SERVICE BULLETIN SB271107

ICON CONTAINER GROMMET INSPECTION Issue Date : November 27, 2007

Status : Precautionary

Pictures:

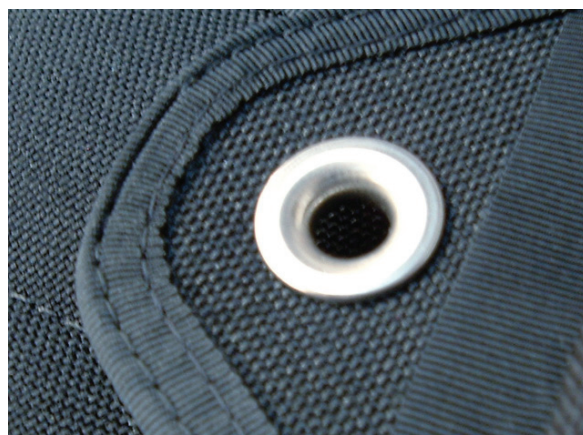
The Damage can be seen on the inside of the Grommet where the Closing Tool has scratched the Inside Surface of the Grommet. The seating of the Grommet needs to be inspected to ensure correct and flush seating of the Grommet.

1. Damaged Grommet
see damage on inner ring of grommet

1. Undamaged Grommet

This could well be an isolated incident, but as a matter of precaution Aerodyne is recommending all Grommets on the ICONs listed in the Identification paragraph above be Inspected.
